RIGOH	Technical Bulletin			No. RTB-006
SUBJECT: Ink Cartridge Seal				DATE: Nov.30 1990 PAGE: 1 of 1
PREPARED BY: S.Asai CHECKED BY:		FROM: Copier	Technic	cal Support Section
CLASSIFICATION: Action Required Troubleshooting Retrofit Information	Revision of some linformation of the linformat		Ges 5	EL: 5/955 5230/5270 1160/1170

RIGOH	Technical	Bulletin		No. RTB-007
SUBJECT: Drum Retro	ofit to prevent Ink Leakage	(Refer to M/B No.	21)	DATE: Jan.31.1991 PAGE: 1 of 3
PREPARED BY: S.Asa CHECKED BY:	ai	FROM: Copier T	echnic	cal Support Section
CLASSIFICATION: Action Required Troubleshooting Retrofit Information	Information		Ges 5	EL: 5/955 5230/5270 I160/1170
A drum blades kit has been registered as a spare part. With this retrofit kit, technicians can

RIGON	Technical	Bulletin		No. RTB-008
SUBJECT: Thermal Head Clean	er Cap			DATE: Jan.31th '91 PAGE: 1 of 2
PREPARED BY: S.Asai CHECKED BY:		FROM: Copier	Technic	cal Support Section
CLASSIFICATION: Action Required Troubleshooting Retrofit Information	Revision of s Information of the control of the con	service manual only	Ges 5	EL: 35/955 5230/5270 1160/1170

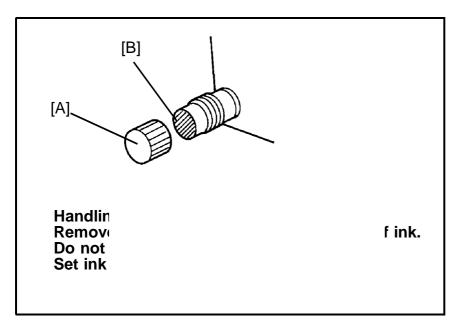
A transparent seal will be added to the exit of the ink cartridge (all colors) to prevent ink from being spilled on the floor during cartridge installation. It is not necessary to remove this seal; a projection on the ink pump inlet breaks this seal when the cartridge is set into the drum cartridge holder.

This modification will be implemented in the December production run. The following illustration and instructions will be printed on all ink cartridges early next year. This instructs the customers not to remove the seal at installation.

SUBJECT: Drum Retrofit to prevent Ink Leakage

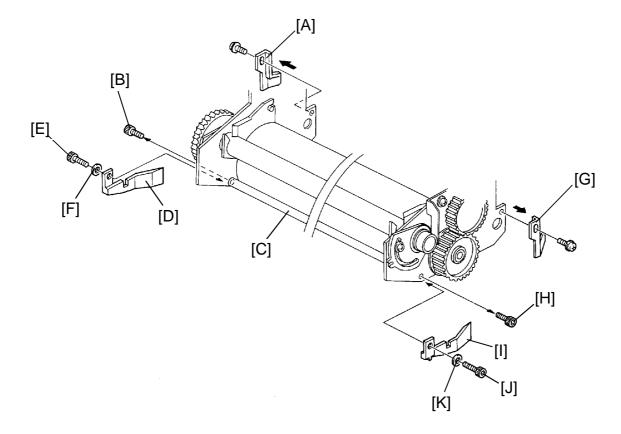
4. Remove the old front drum blade (C2004745) [A] (1 screw).
5. Remove the internal hexagon head screw (M4 x 6) [B] securing the ink roller shaft stay [C], then install the new front drum blade (C2074745) [D] and secure it with the internal hexagon head screw (M4 x 8) [E] and the flat washer [F].

6. Remove the old rear drum blade (C2004746) [G] (1 screw).

7. Remove the internal hexagon head screw (M4 x 6) [H] securing the ink roller shaft stay [C], then install the new rear drum blade (C2074746) [1] and secure it with the internal hexagon head screw (M4 x 8) [J] and the flat washer [K].

Note: Do not re-use the old front and rear drum blades.

SUBJECT: Drum Retrofit to prevent Ink Leakage

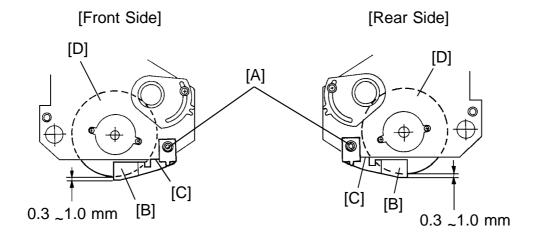
1. Tighten each (front and rear) internal hexagon head screw [A] so that the drum blade [B] contacts the lower edge [C] of the side plate.

Note 1: Make sure that the clearance between the ink roller [D] and the drum blade [B] is 0.3 to 1.0 mm.

Note 2: Make sure that the drum blade edge [E] contacts the ink roller [F].

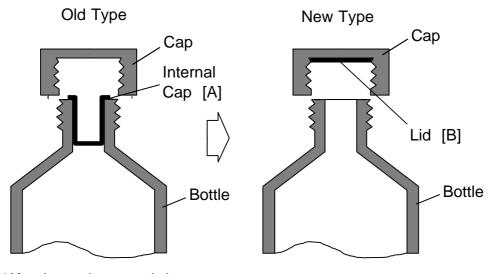
There has been a problem with the internal cap [A] getting stuck inside the thermal head cleaner bottle and it is difficult to pull it out.

The internal cap has been changed to a lid [B] as illustrated below:

This modification has been implemented since the November '90 production run. Please note that the part number of the thermal head cleaner remains the same.

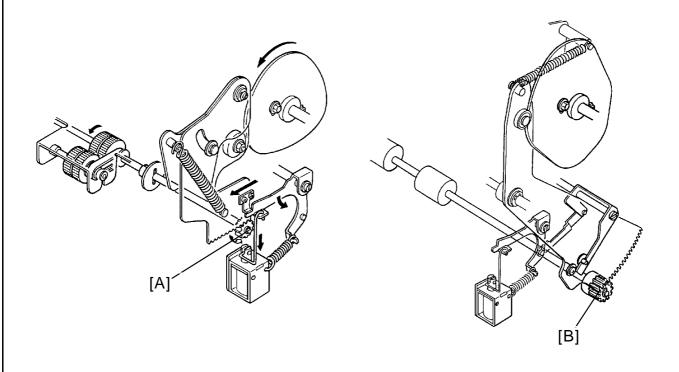
The one-way clutches inside the paper feed and second feed roller gears have worn the roller shafts smooth. The clutch slips and paper jams or is not fed. This tends to occur during high speed printing and is more likely to occur on machines that exceed the recommended monthly copy volume. When the feed mechanism is manually operated to check the paper feed, paper feeds correctly.

- 1. Remove the paper feed roller gear [A] and the second feed roller gear [B].
- 2. With fine sandpaper, lightly sand the roller shaft surface at the point where it comes into contact with the one-way clutch. This increases the coefficient of friction.
- 3. If paper jams continue to occur, replace the one- way clutch.
- 4. If paper jams continue to occur, replace the roller shaft together with the one-way clutch.

RIGOH	Technical	Bulletin		No. RTB-012
SUBJECT: Paper jamming arour	nd the drum			DATE:June 15 '91 PAGE: 1 of 1
PREPARED BY: S.Asai CHECKED BY:		FROM: Copier	Technic	cal Support Section
CLASSIFICATION: Action Required Troubleshooting Retrofit Information	Revision of s	service manual only

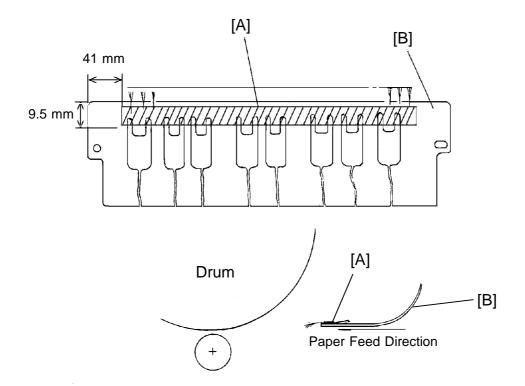
Paper jamming occurs around the drum because of static electricity when the machine is used under low humidity conditions. Heavy static charges will build up around the master during the printing run. This happens particularly when thin paper is being used at high speed rotations. This also happens if the original (and therefore the master on the drum) is changed.

Stick the antistatic brush (P/N: C2079010) [A] on the upper second feed roller guide plate [B] as illustrated below: (The antistatic brush has been registered as a spare part.)

Note: Depending on the type of paper and/or the environment, paper might still jam even though the antistatic brush was installed on the guide plate.

SUBJECT: Paper exit pawl air pump

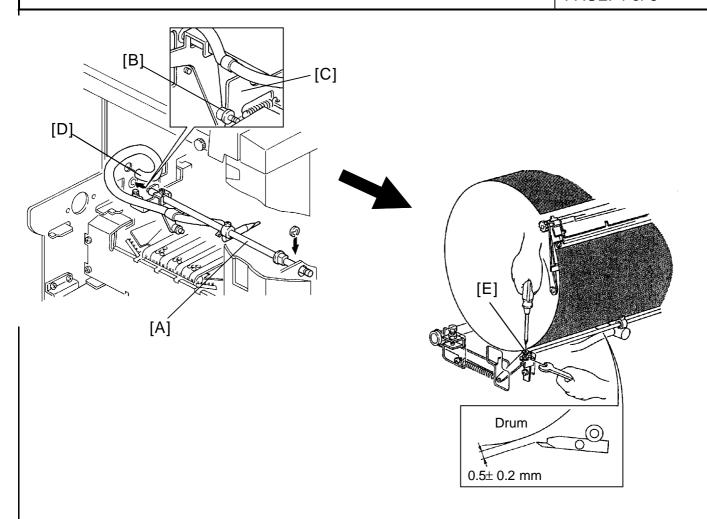
- 1. Open the master eject unit and remove the exit pawl assembly [A] (1 E-ring [B] and 1 spring [C]) from the machine .
- 2. Remove the bushing [D] and the exit pawl lever [E] (1 Allen screw) from the shaft.
- 3. Mount the above exit pawl lever on the new exit pawl shaft [F] (1 Allen screw used on the previous shaft) and insert the bushing onto the shaft.

SUBJECT: Paper exit pawl air pump

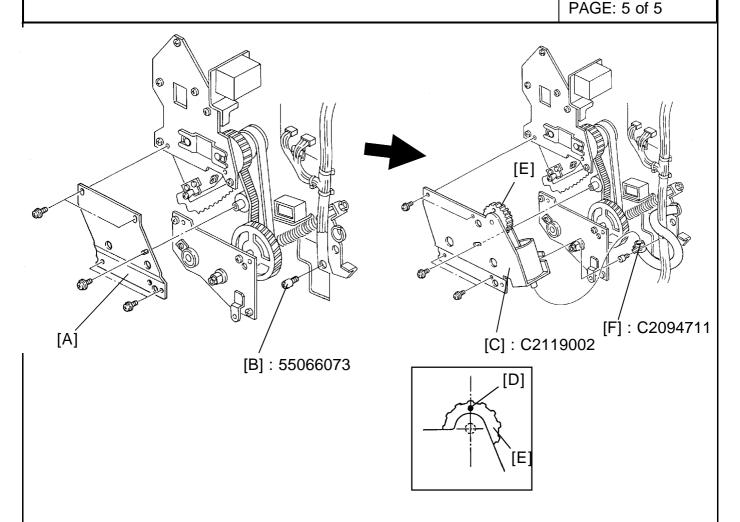
4. Install the new exit pawl unit [A] (assembled on the previous page) to the machine (1 E-ring and 1 spring).

Note: Make sure that the collar [B] on the exit pawl lever is correctly placed on the exit pawl drive cam [C].

5. Insert the edge of the vinyl hose [D] into the hole on the rear side plate as shown.

- 6. Manually turn on the paper feed and printing pressure solenoids. Using a spanner (10 mm), gradually rotate the drum rotation shaft counterclockwise to move the exit pawl to the drum.
- 7. When the printing pressure is applied, adjust the clearance between the drum and the exit pawl by turning the screw [E]so that it is 0.5 ± 0.2 mm.

Note: Make sure that the exit pawl does not contact the drum surface and the master clamper several times when the printing pressure is applied.
